Symptom

Vibrating plate does not vibrate properly.

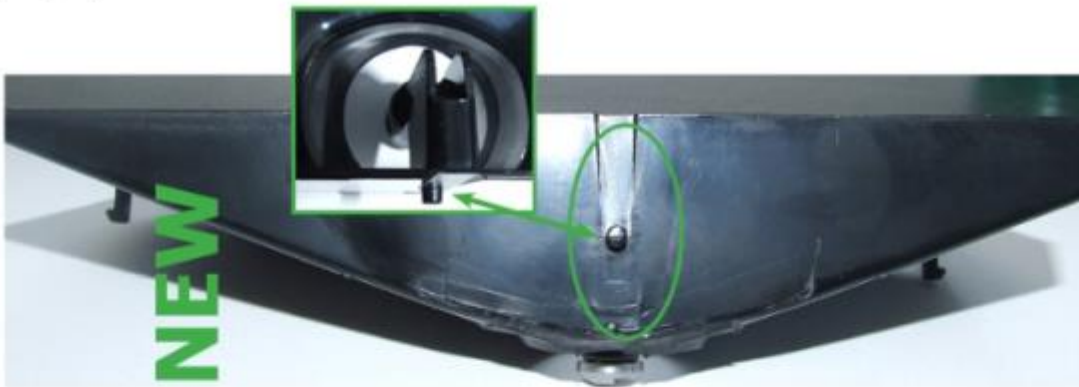
From **SN TU901431108216** we have introduced a molded seal to prevent beans from sliding below the bean container. Image 1 - 2

From **SN TW901525318497** the bean inlet is having a pin to improve the vibration. (Image 3)

Actions: For affected machines (**up to SN TW901525318496**) order both:

- Bean Container: code 421944052791 BLK ADDITION.BEAN CONT.COST.V5 HGO ASSY (Image3)
- Bean Container Inlet: code 421940813151 KIT SPARES BLK REMOV.COF.CONT.HGO ASSY. Image4)
